May 22, 2018

Mr. Frank DeFrancesco, Chief
Dams and Waterway Section
Pennsylvania Department of Environmental Protection
2 East Main Street
Norristown, PA 19401

**Re: SPLP Response to Comments
Hydrogeological Reevaluation Report
Arch Bishop/South Chester Road HDD (S3-0541)
DEP Permit Nos. E15-862 and E23-524
Westtown and Edgemont Townships
Chester and Delaware Counties, Pennsylvania**

HDD PROFILES WITH WELL LOCATIONS, WATER LEVELS, AND FRACTURE TRACE LINES

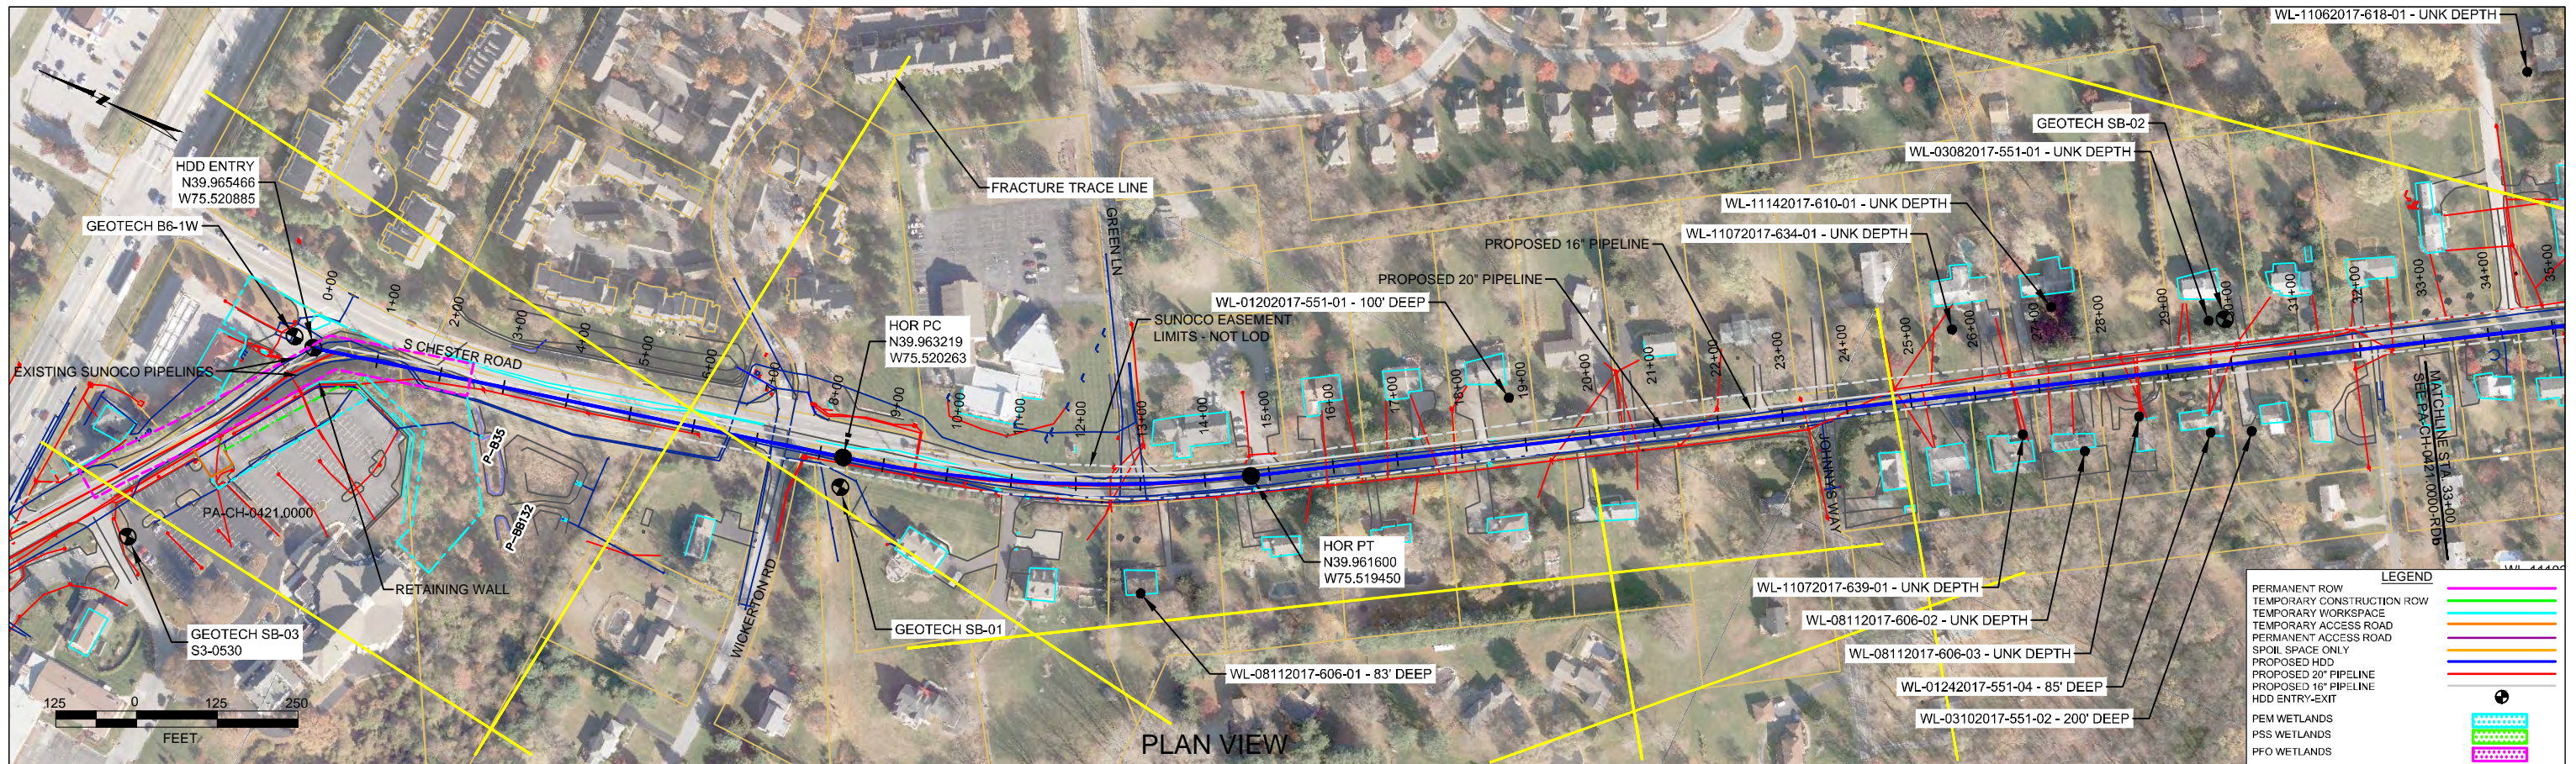
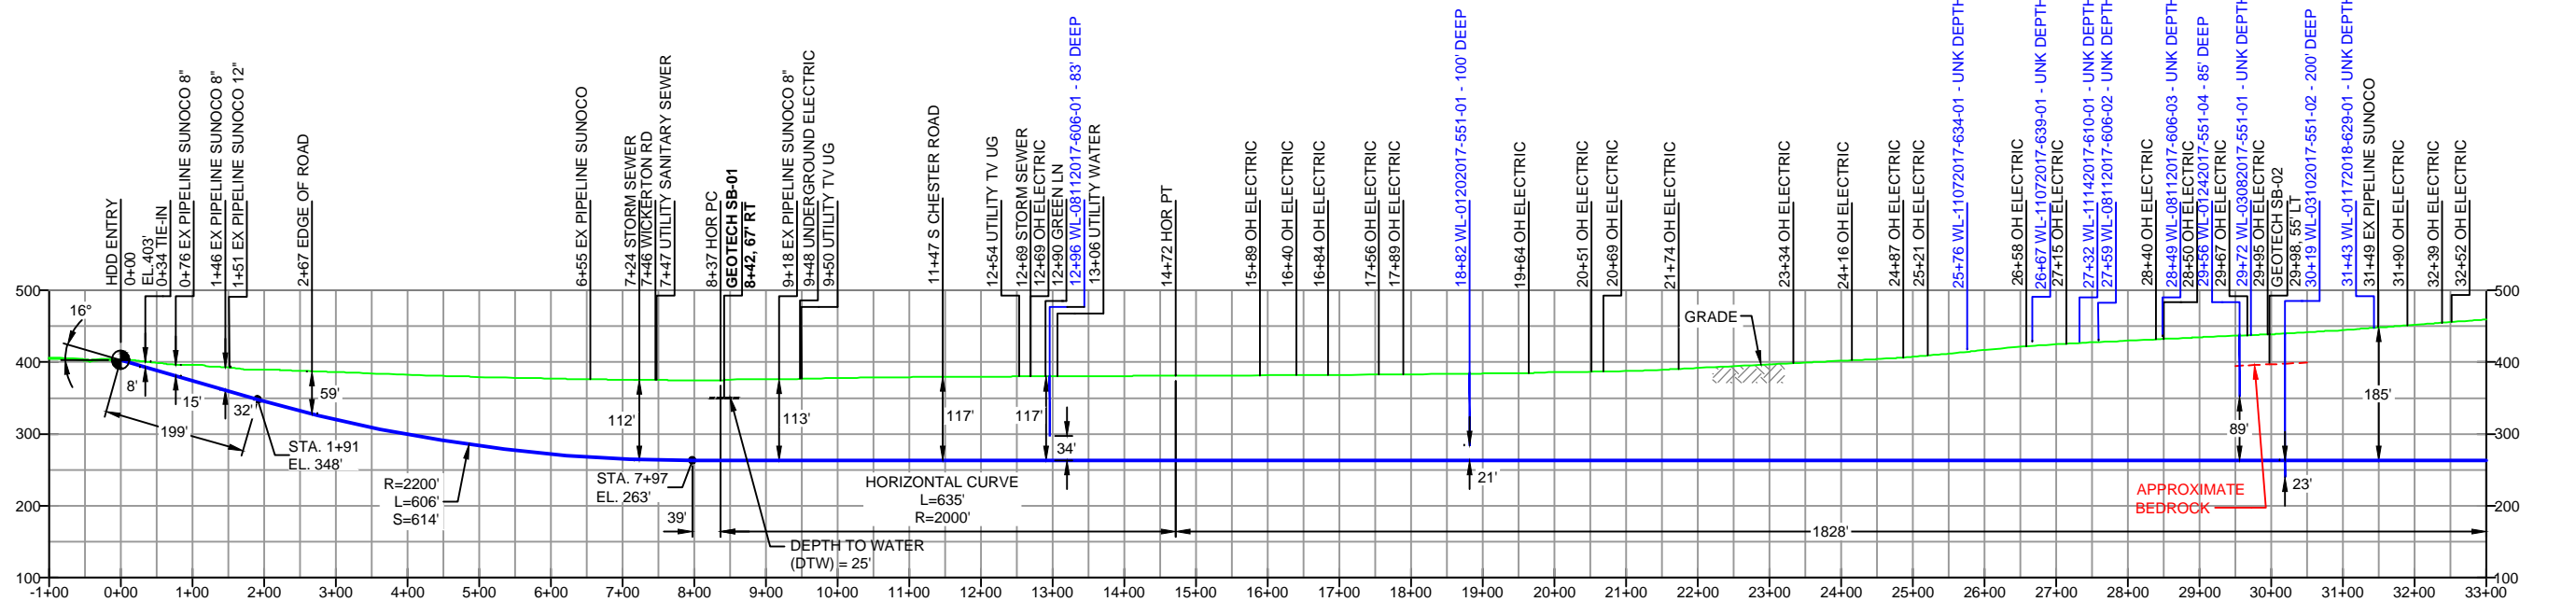
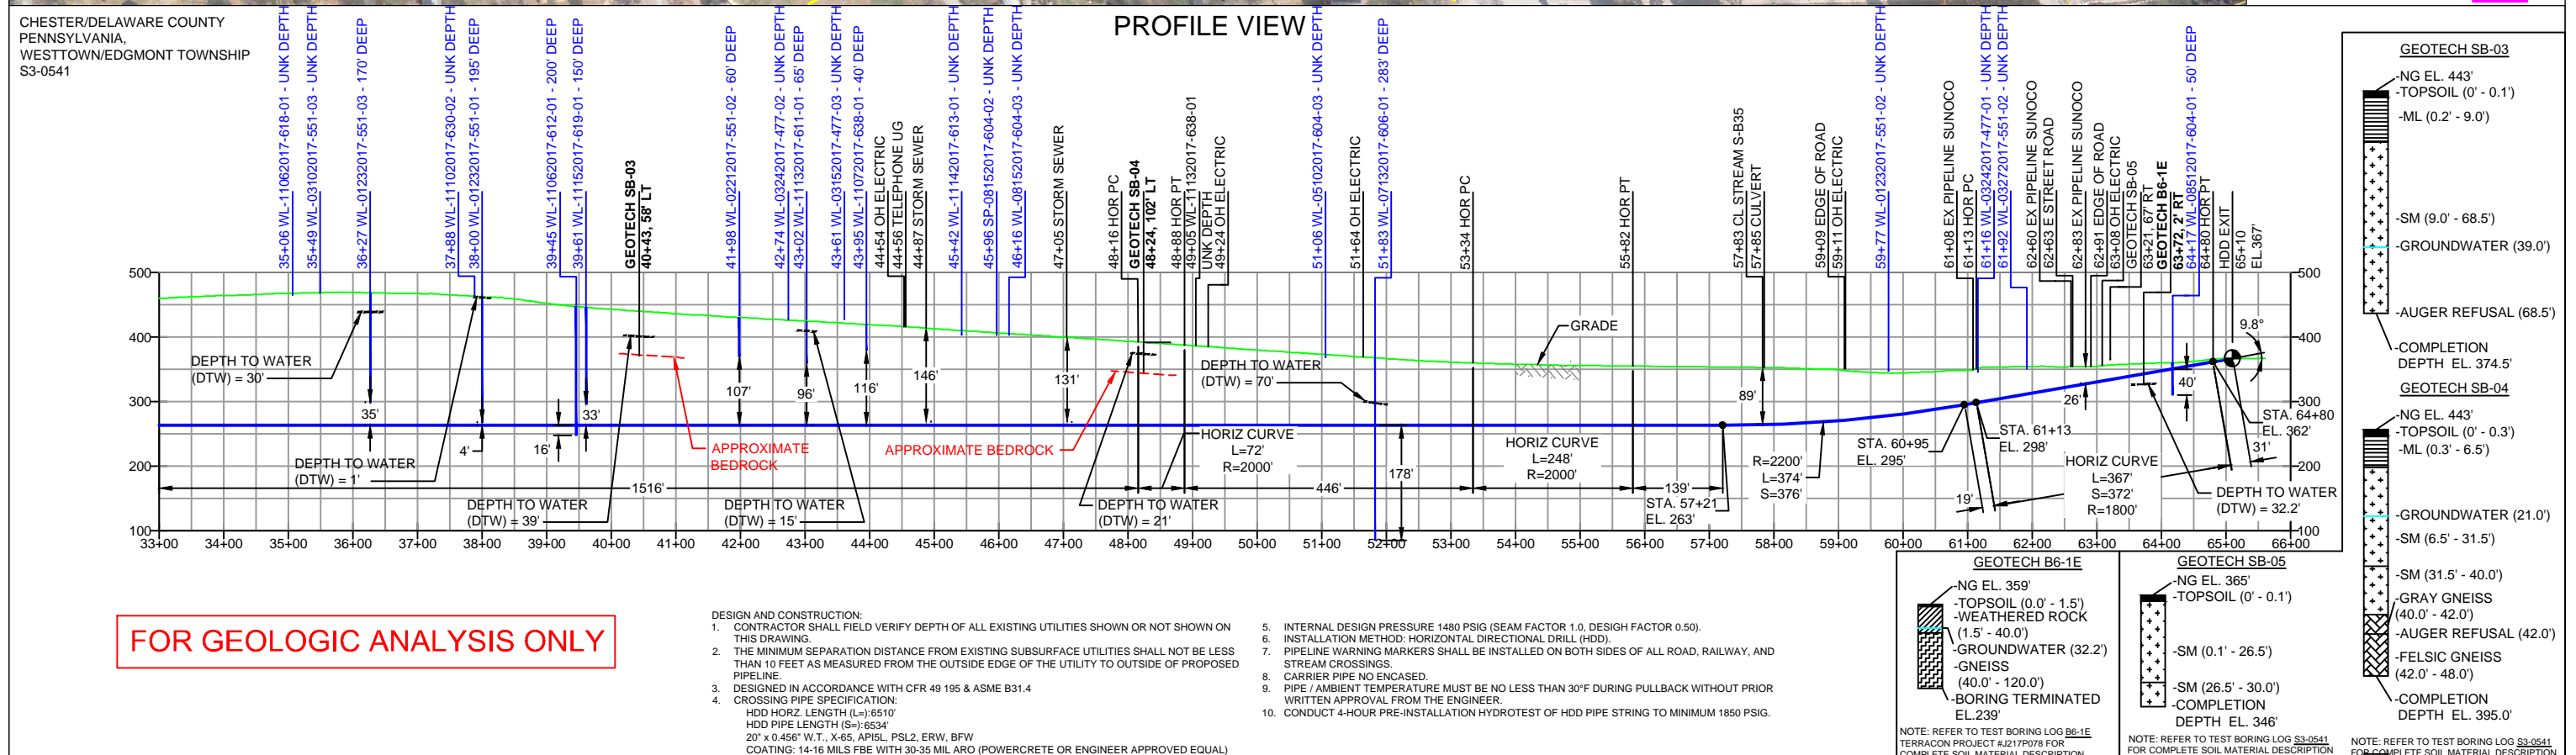
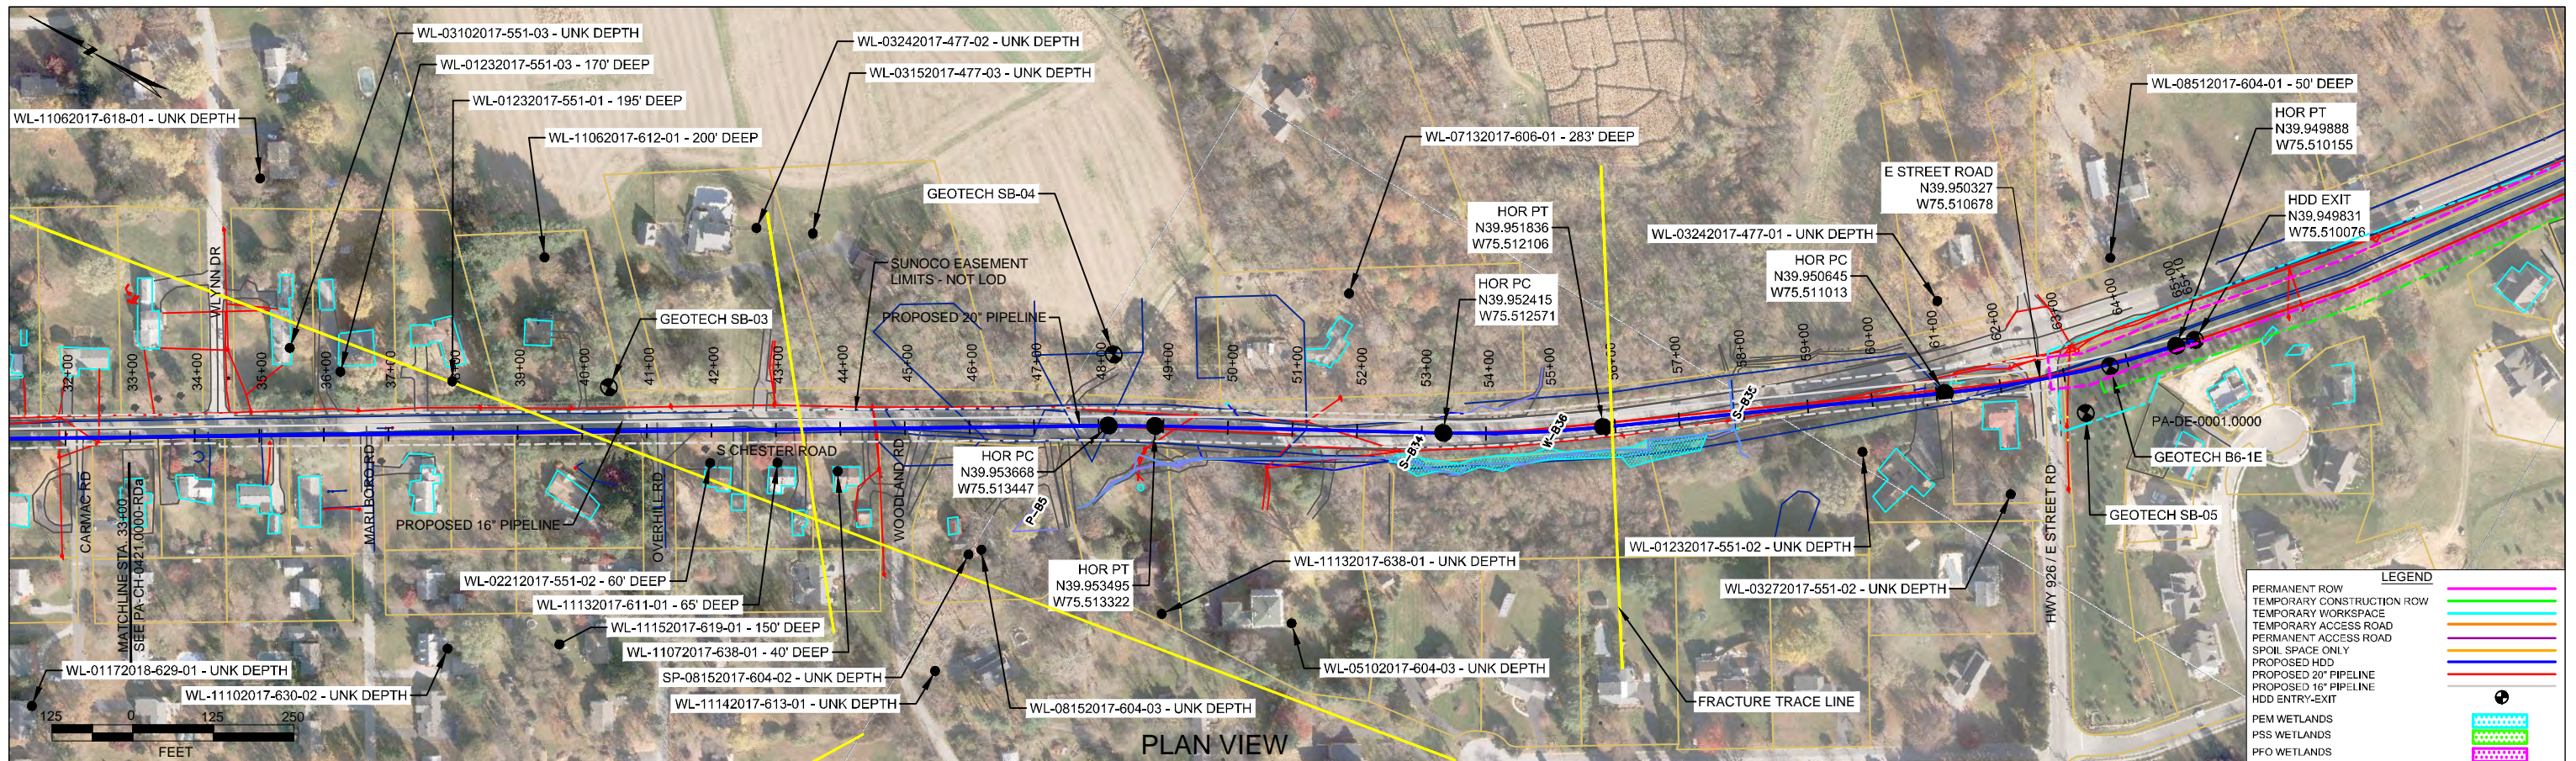
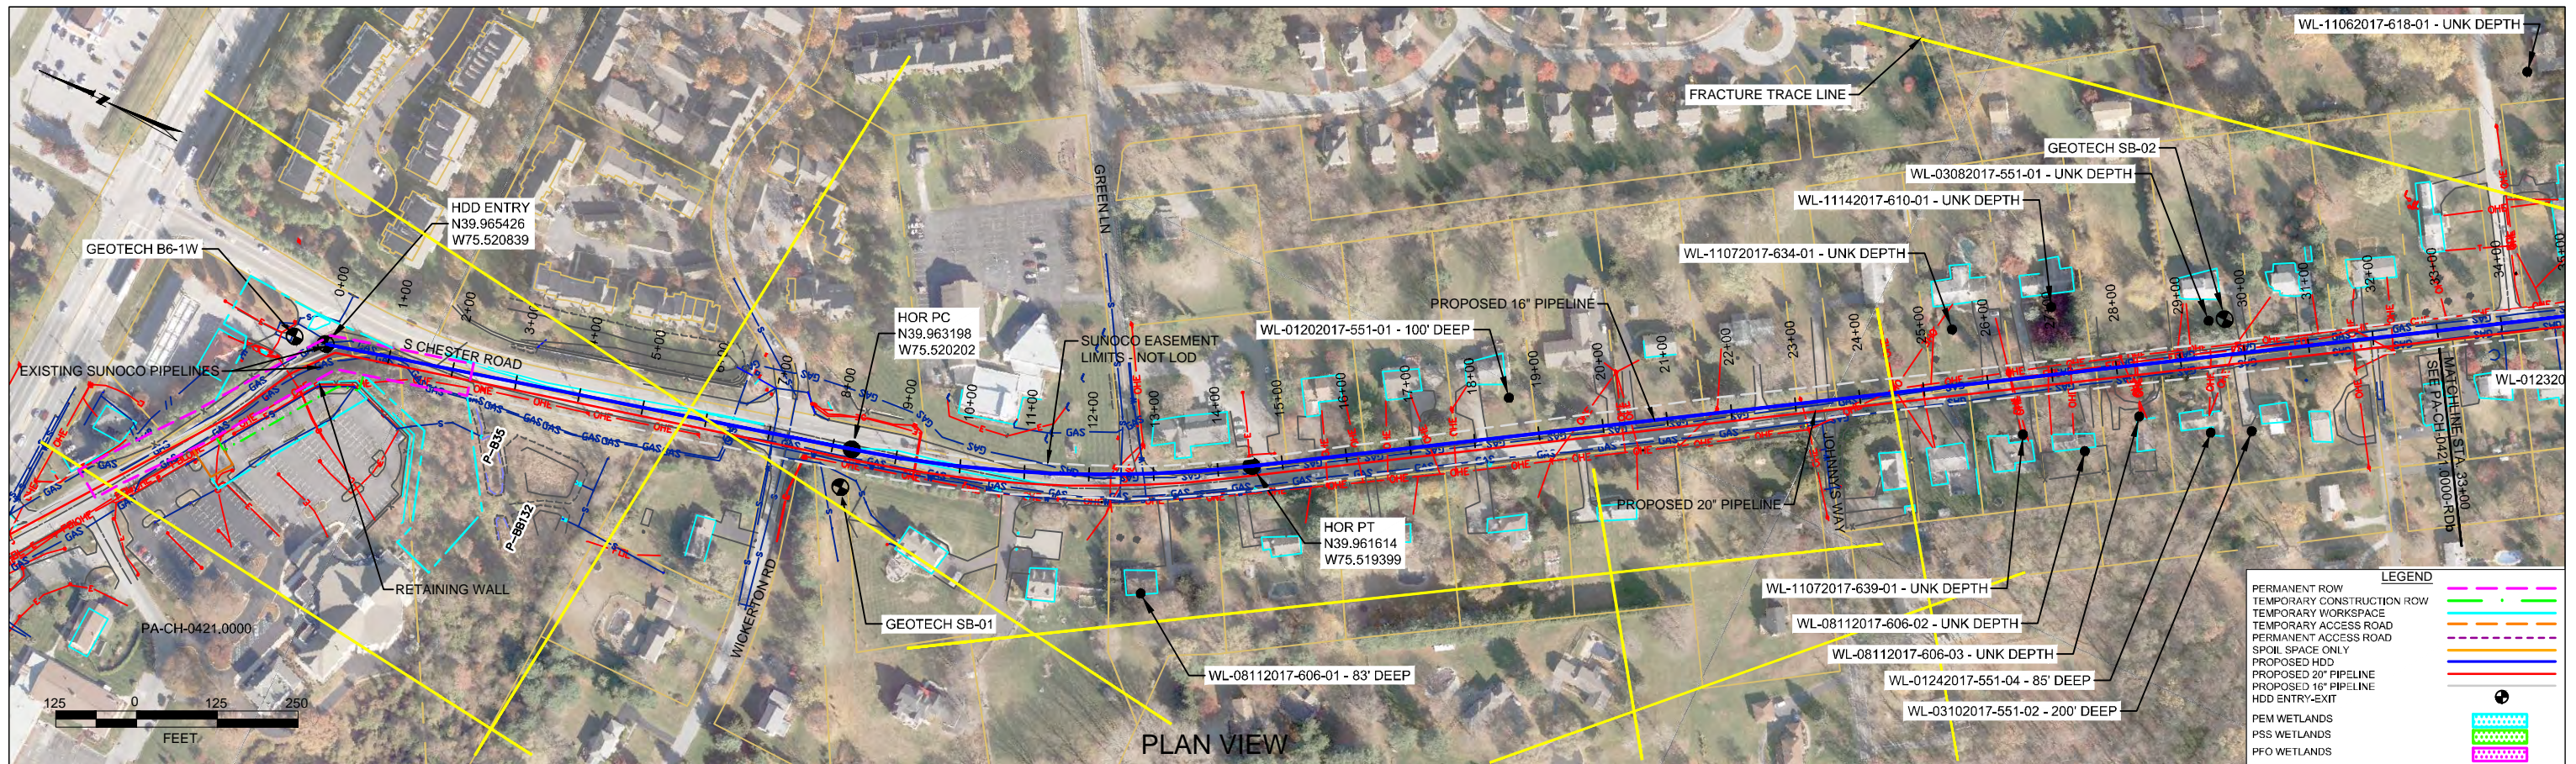
6. There are reported intersections of fracture traces with the planned HDD bore path within close proximity to residential supply wells. The HDD alignment crosses six fracture traces mapped as part of reevaluation, but these fracture traces are not discussed as they relate to well locations and proximity to bore path. Further discuss these fracture traces, map them on present day aerial photos, evaluate them for potential problem areas, and provide this information, including the results of the evaluation, to DEP.

- b. Project water wells depths, casing depths and water-level depths (based on a water-level survey) on cross sections/profile views.**

- c. Identify zones of fractures or fracture trace intercepts on the profile views, along with residential water supply well locations.**

b. The top of rock level appears to be 22 feet below ground surface at Boring B6-1W and there is likely shallow depth-of-cover over the HDD bore at the existing Sunoco pipeline crossing (Station 1+06) as well as at Wickerton Road (Station 1+75). The Report explicitly states that casing is being provided for the pilot hole at the SE entry, but does not state the same for the NW entry. This needs to be clarified.

A plot of the approximate fracture traces on the HDD profile (see **Attachment 4**) indicates that several residential wells in the 450-foot sampling program may lie on or near a potential fracture. The fracture trace locations were derived from stereographic imagery using aerial photographs from 1943, and then transposed on current aerial maps; thus, a small degree of error in plotting accuracy exists, and the fracture trace locations are described as “approximate.” Fracture traces are the surface representation of vertical to near vertical planar zones of fracture concentration, thus a well would have to be very close to a fracture trace to be intersected by it. The wells which are closest to fracture traces are from 54 to approximately 500 feet from the HDD borepath, occurring between Stations 35+00 to 45+00 as shown on the HDD profiles. The use of Aquabloc will mitigate the travel of groundwater through fractures, and of drilling fluids away from the bore path. SPLP will follow the Operations Plan and Water Supply Plan, by adhering to the notification, sampling, and monitoring procedures outlined therein, to ensure all affected residents will have potable drinking water. (Also see answer to 5(a).)

Attachment 4 presents a set of the HDD profiles with water well depths and water levels if known represented in the cross-section view.

The set of HDD profiles in Attachment 4 has the fracture trace intercepts included on the plan view.

As shown on the HDD profiles, the occurrence of a Sunoco pipeline at Station 1+06 is on the proposed 16-inch profile (Station 0+76 on the 20-inch profile). On both profiles, the area

around Station 1+75 is noting “edge of road”. Wickerton Road occurs at Station 7+48 on the 16-inch profile and Station 7+46 on the 20-inch profile.
